A FURTHER REVIEW OF THE CALIFORNIA STATE UNIVERSITY'S CONTRA COSTA CENTER

COMMISSION REPORT 89-9
PUBLISHED MARCH 1989

A Further Review of the California State University's Contra Costa Center

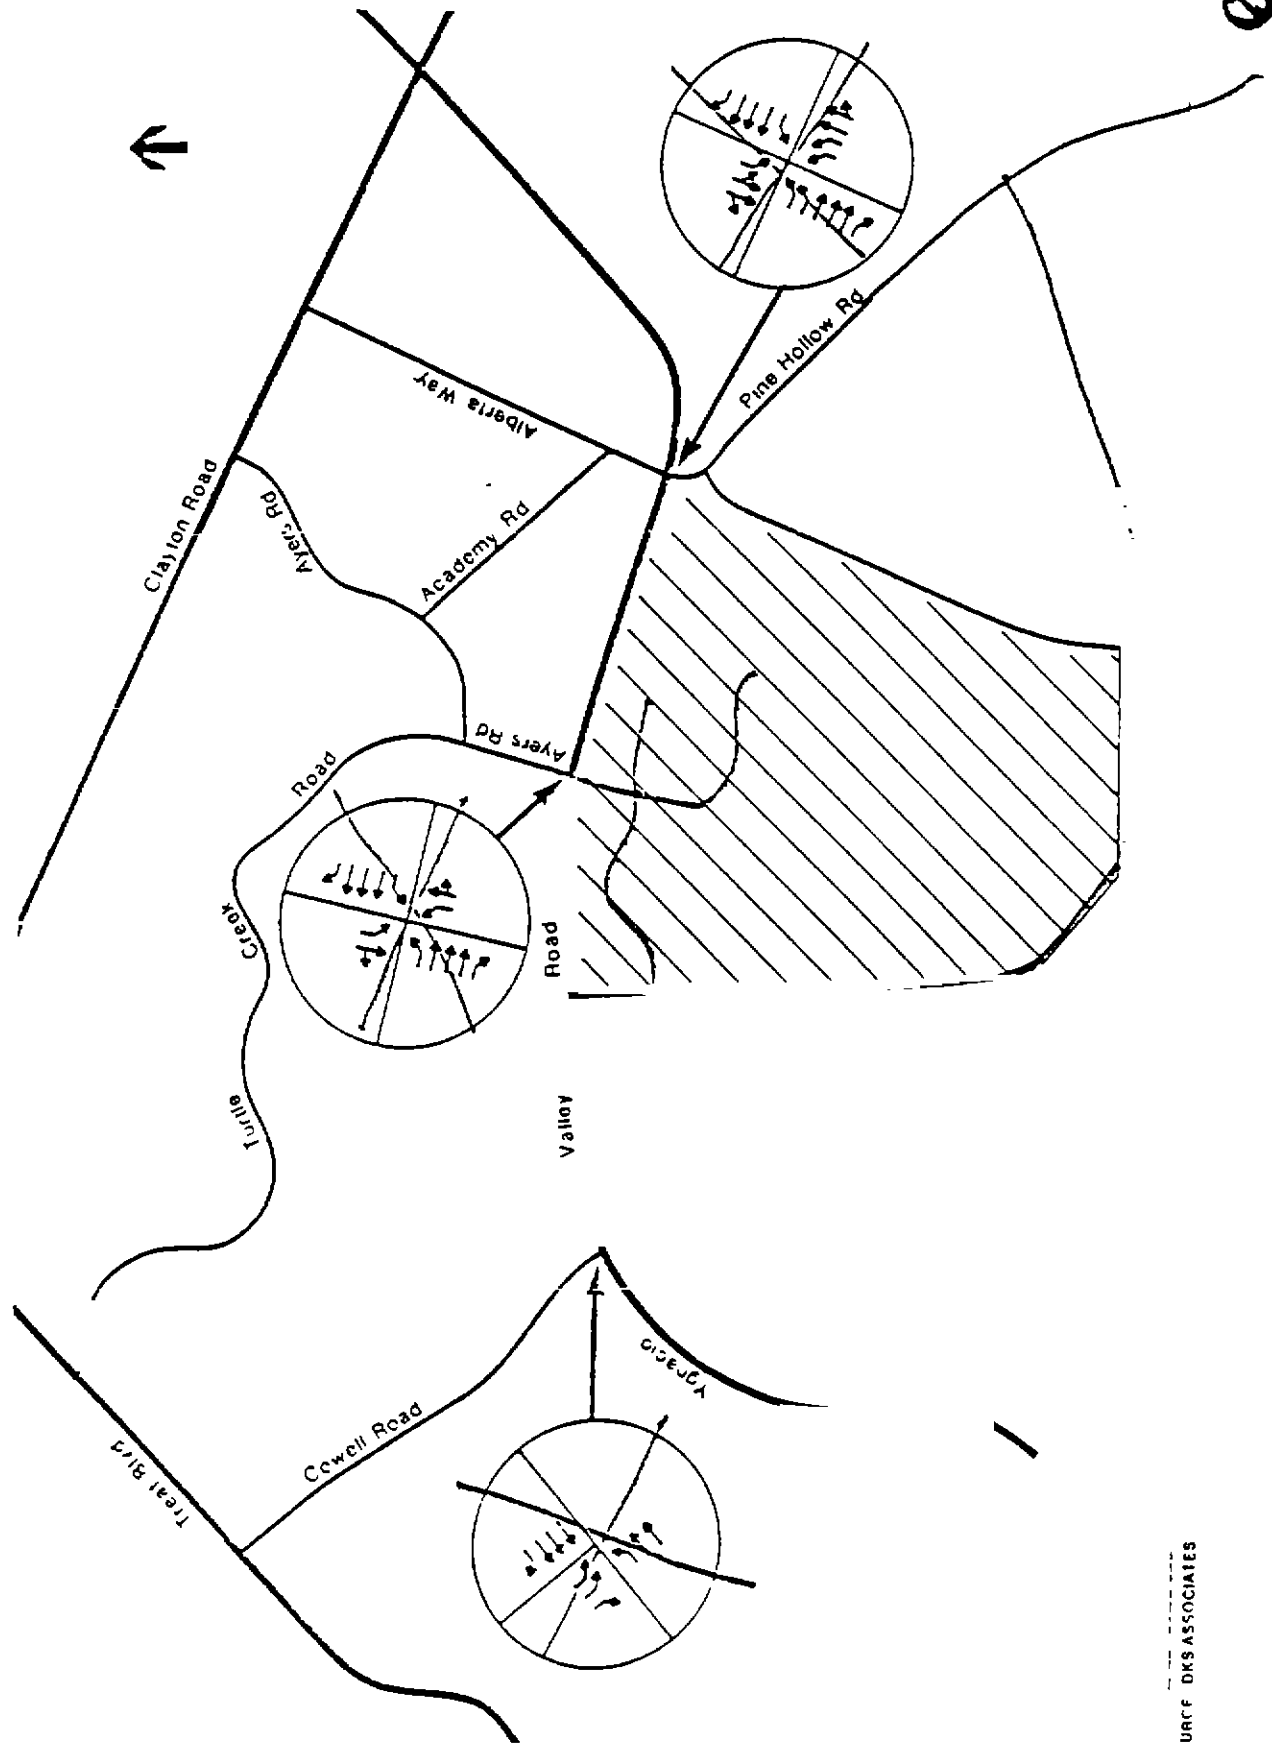
- B The obvious location for access to adjacent parcels is lined out on Exhibit 2 (attached). This would extend up the scale splitting the flow line or running to the west of the flow line to facilitate retention of storm and ground water run off. The advantages and disadvantages of such a roadway to the off campus center should be discussed and responsibilities for any further plan development and/or implementation needs clearly defined

YEAR 1992 MITIGATED STREET GEOMETRICS

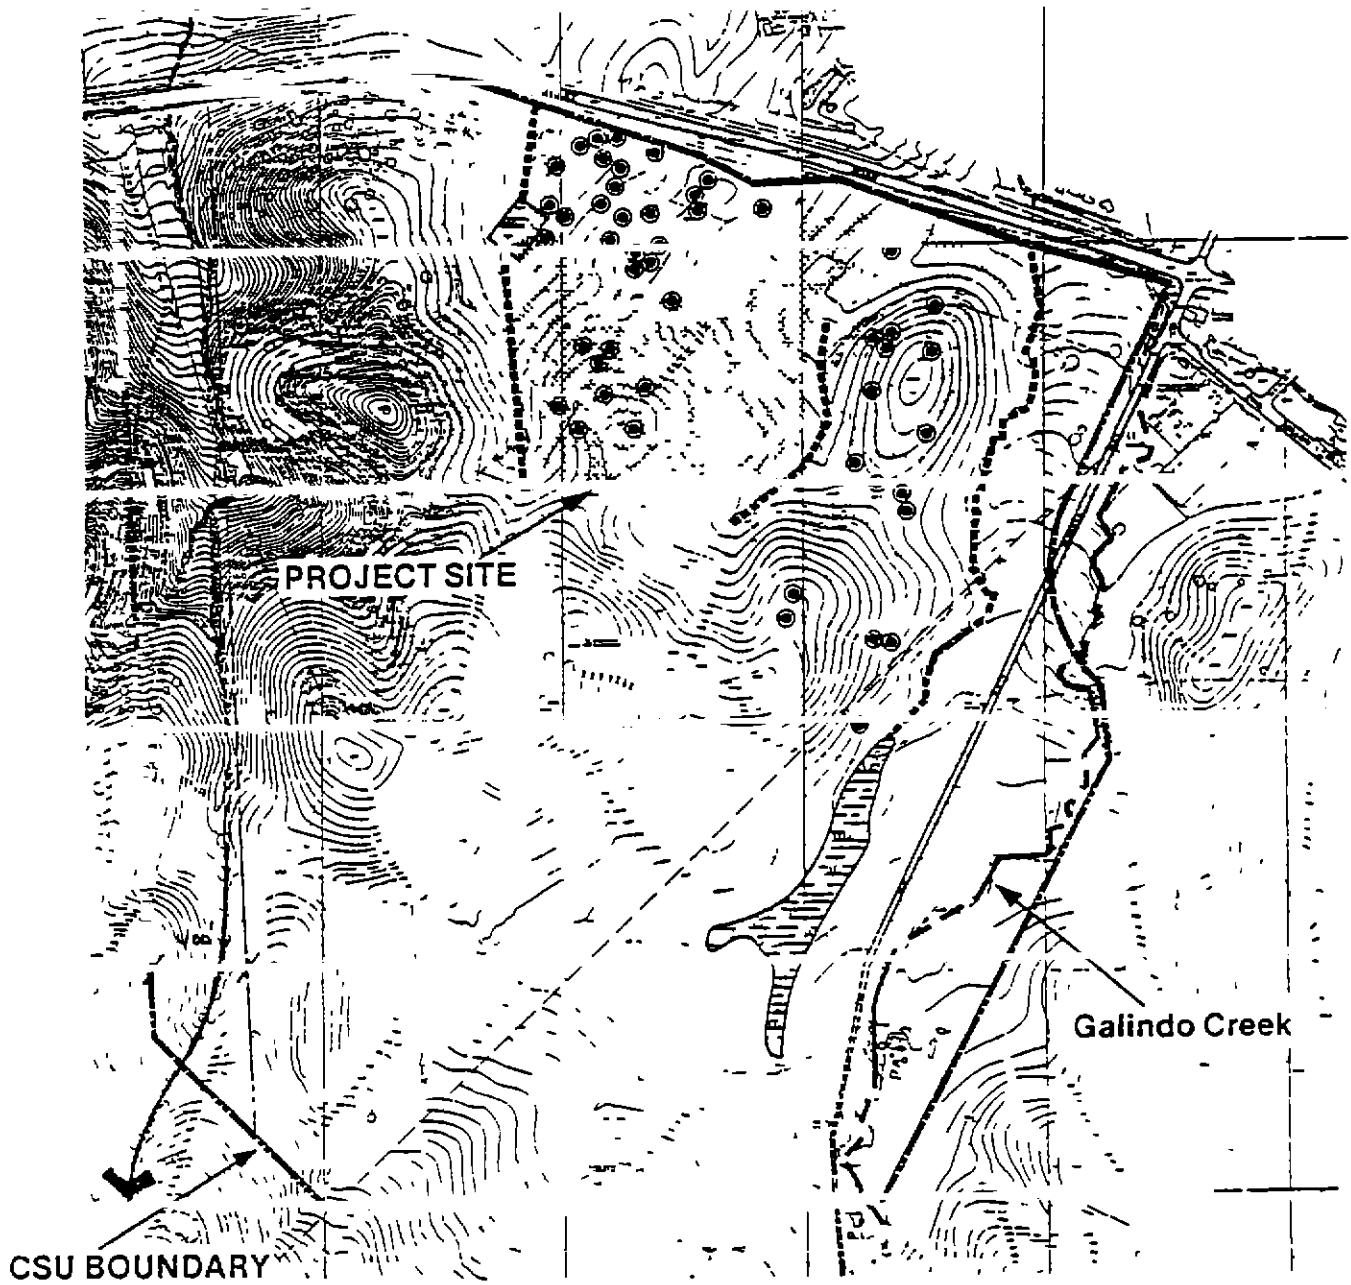
The proposed mitigation measures discussed in the text do not correspond to the lane assignments in figure 4-5.

The intersection of Alberta Way and Ygnacio Valley Road, Year 1992 (figure 4-5), is shown to have a combined through and left turn lane. This lane assignment necessitates approach phasing. The City does not prefer this type of phasing. Do the level of service calculations consider approach phasing at this location?
